DART AEROSPACE LTD		Work Order:	150581
Description: Bar		Part Number:	D3196-3
Inspection Dwg: D3196 Rev: C		Page 1 of 1

DESIGN <i>qp</i>	DRAWN BY <i>JB</i>	DART AEROSPACE LTD HAWKESBURY, ONTARIO, CANADA	
CHECKED <i>PH</i>	APPROVED <i>JB</i>	DRAWING NO. D3196	REV. C SHEET 1 OF 3
DATE 06.10.31	TITLE BAR		SCALE 1:4
A	03.06.25	NEW ISSUE	
B	06.09.25	ADD D3196-5	
C	06.10.31	ADD SLOTS ON -1; REMOVED -5

DRAWING NO. D3196	TITLE BAR	REV. C	DART AEROSPACE LTD ENGINEERING ORDER		D.E.O. NO. D3196-C-1	SHEET NO. SHEET 1 OF 2	SCALE NTS
DRAWN <i>ASS</i>	CHECKED <i>[Signature]</i>	MFG. APPR. <i>[Signature]</i>	APPROVED <i>[Signature]</i>		DE APPR. <i>[Signature]</i>		
DATE 08.08.27	DATE 08.08.28	DATE 08.08.29	DATE 08.08.29	DATE 08.08.29	DATE 08.09.04

SHEET 1 MODIFY SLOT DIMENSIONING ON D3196-1 AS SHOWN:

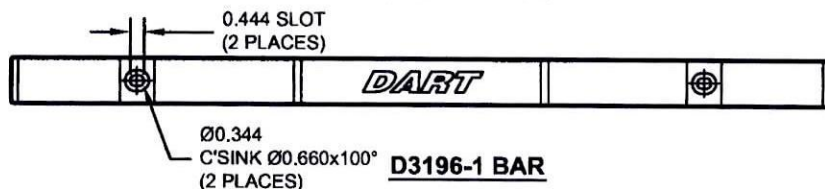
IS:

WAS:

NOTE: THIS CHANGE HAS BEEN DONE TO CLARIFY SLOT DIMENSIONS ONLY. NO CHANGES HAVE BEEN MADE TO THE PARTS
SEE NCR 08-051 FOR FURTHER INFORMATION
ALL OTHER INFORMATION REMAINS UNCHANGED

SHEET 2 MODIFY SLOT DIMENSIONING ON D3196-3 AS SHOWN:

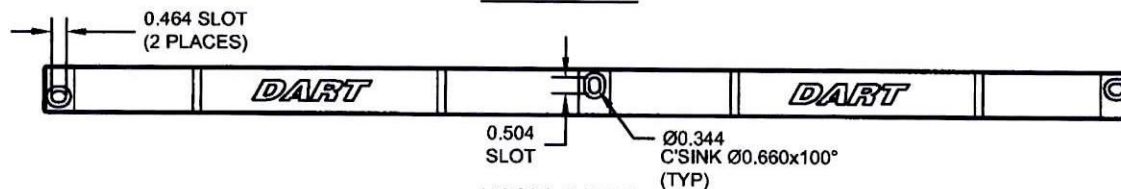
IS:

WAS:

SHEET 3 MODIFY SLOT DIMENSIONING ON D3196-4 AS SHOWN:

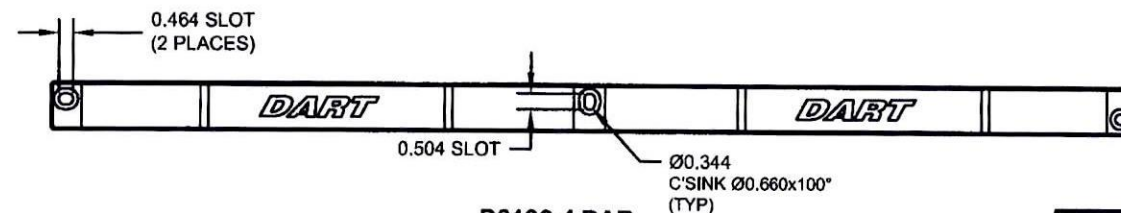
IS:

WAS:
